CHANGE ORDER

Project Name: PA2003 1849 Park Ph2

Change Order No.: 10
Project No.: PA2003
Contract No.: 323000699

Project Name: 1849 Park Phase 2

ELECTRICAL UTILITY SITE PLAN
1
SE001 1" = 60'-0"

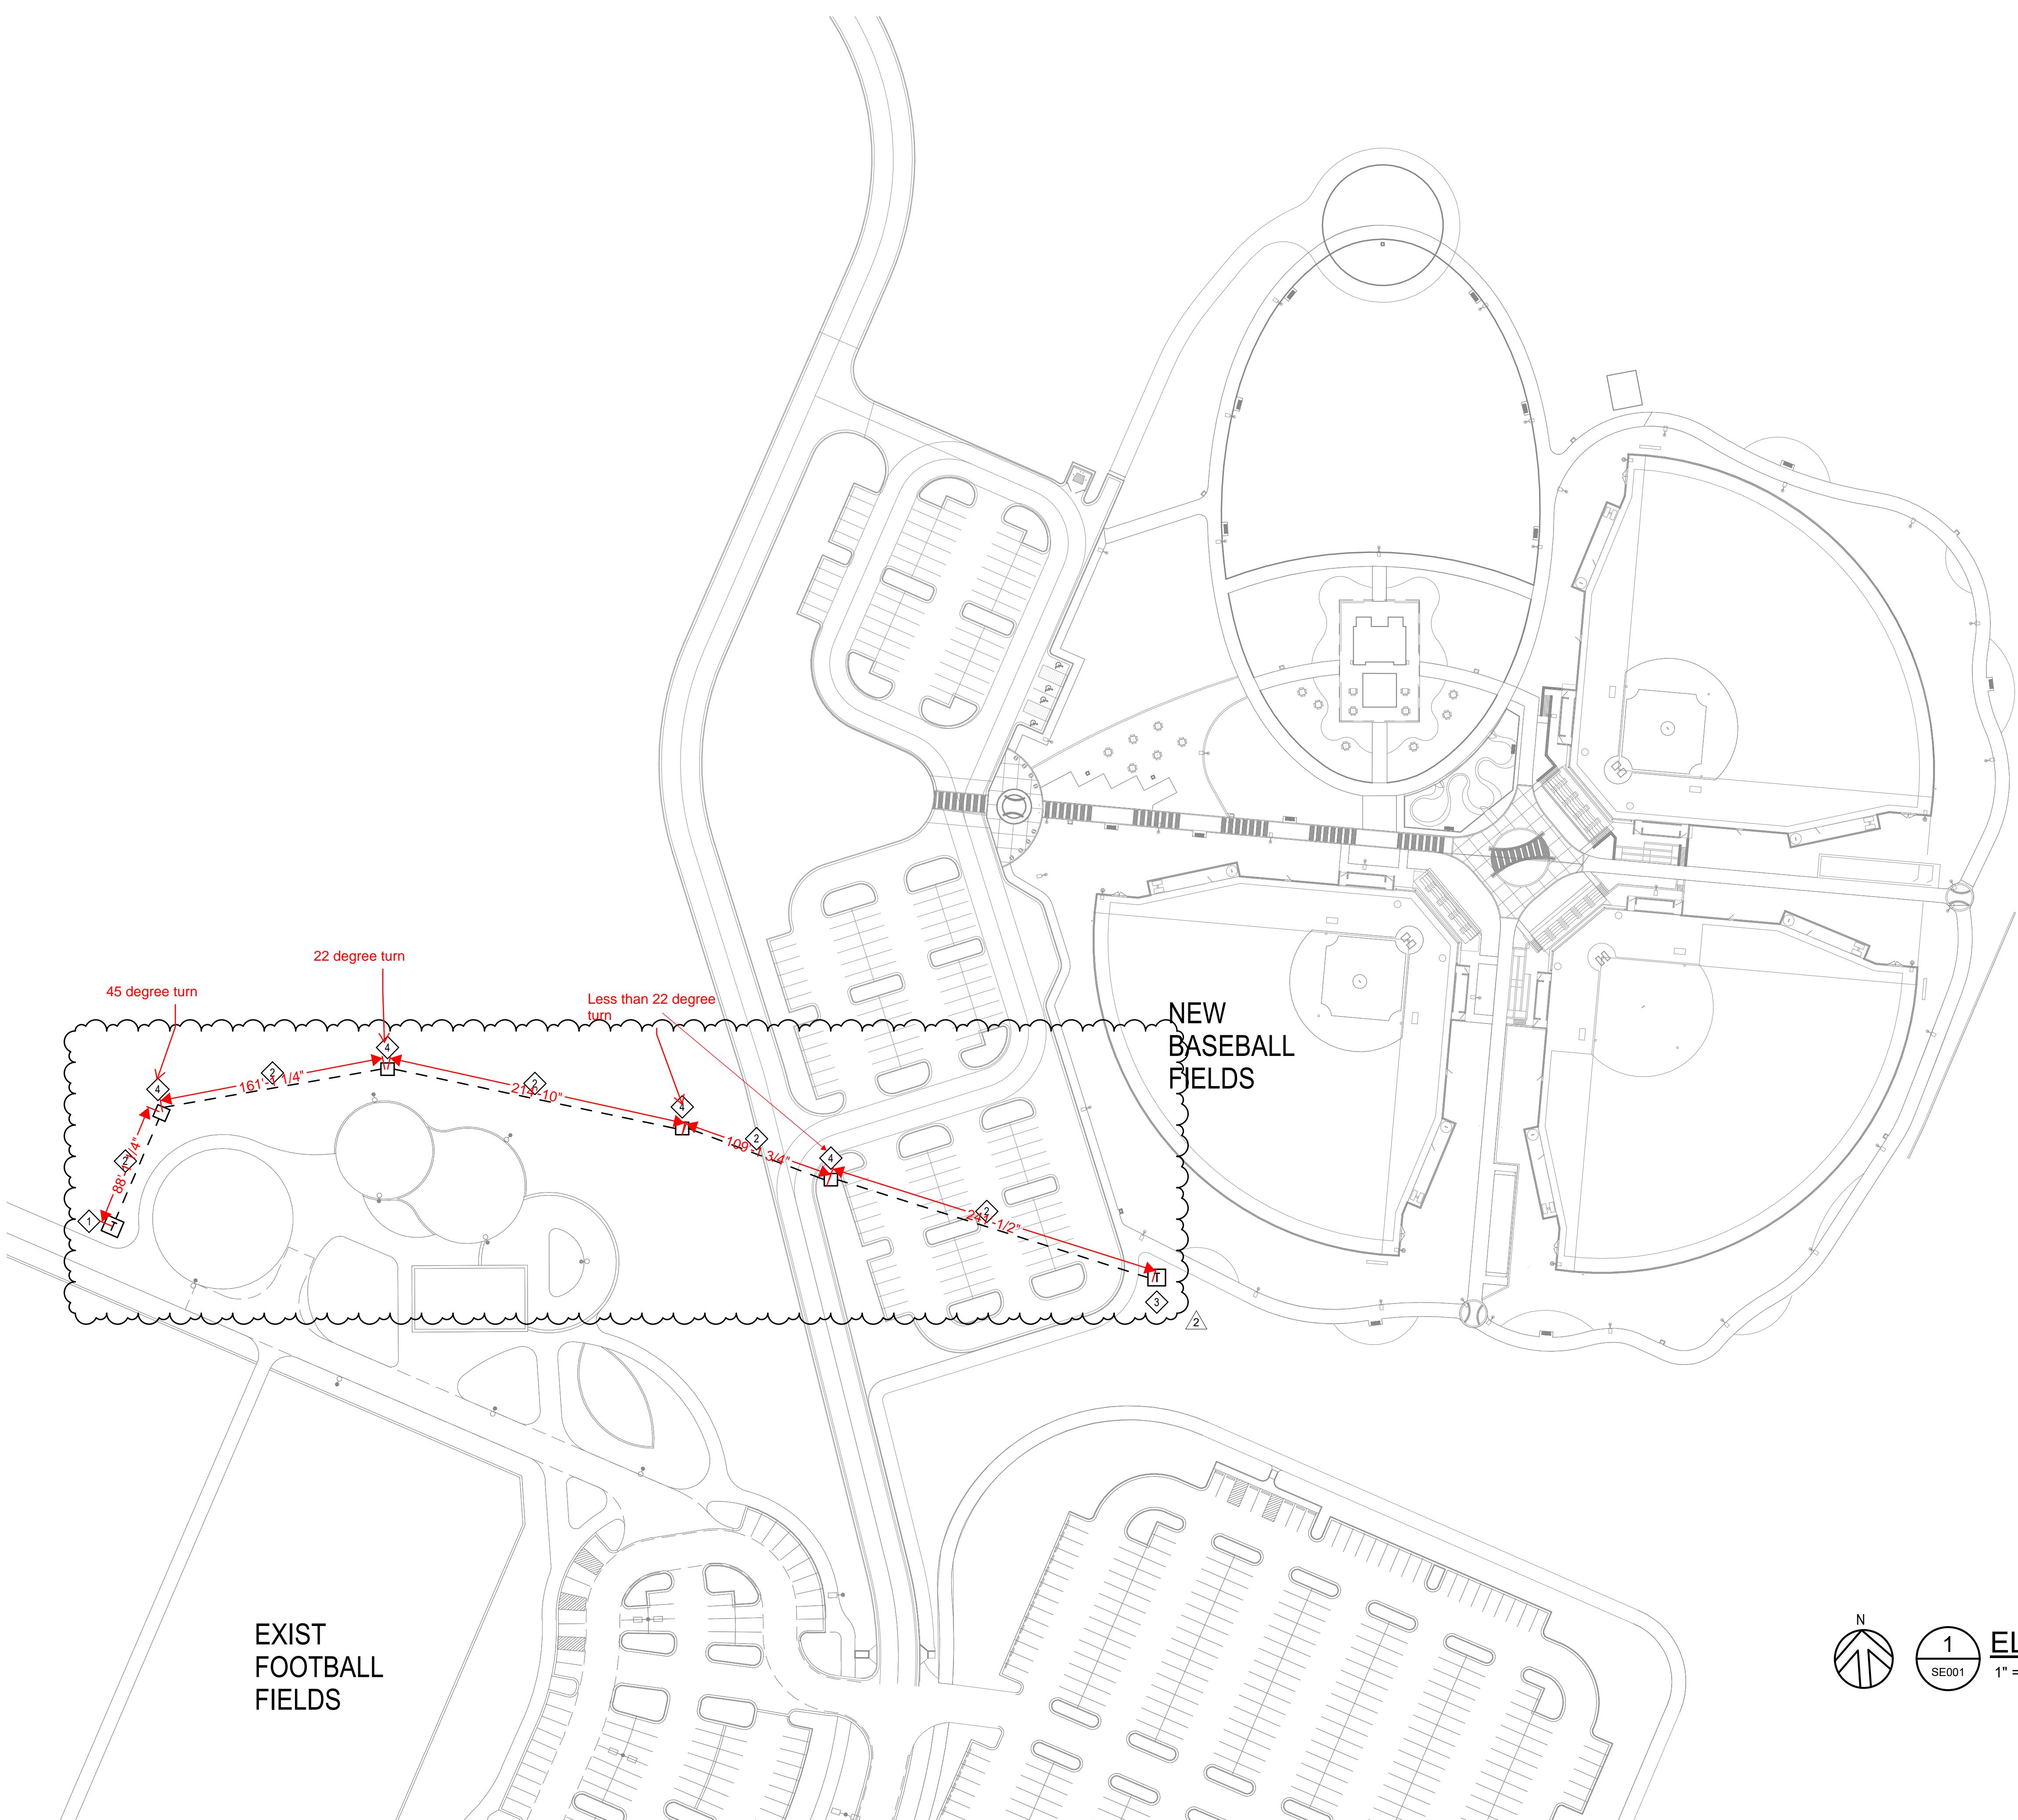
1. All costs associated with the primary raceway routing deviations between sheet SE001 and revised plan.
2. All costs associated with the installation of a single pull box (provided and delivered to the site by others).

6. Installation of one 5/8" ground rod. No additional instruction for grounding provided.
7. All costs associated with the required changes per Encore's inspector. J.S. Electric is to 'sweep' raceways instead of turning them at a 45-degree angle as approved at the first turn leaving the existing transformer.

- EXIST UTILITY TRANSFORMER AT FOOTBALL FIELDS TRANSFORMER TO BE REPLACED WITH LOOP FEED TRANSFORMER. COORDINATE REQUIREMENTS WITH OWNER.
- PROPOSED UC PRIMARY. 2-4" CONDUITS. 3-0" COVER TO THE TOP OF CONDUITS PER ONCOR STANDARDS.
- NEW LOOP FEED UTILITY TRANSFORMER. PROVIDE PAD PER OWNER REQUIREMENTS.
- PROPOSED PULLBOX.

NO.	DESCRIPTION	DATE	DWN.	CHK.
1	CONFORMED SET	07/16/24		
2	UTILITY REVISIONS	03/12/25
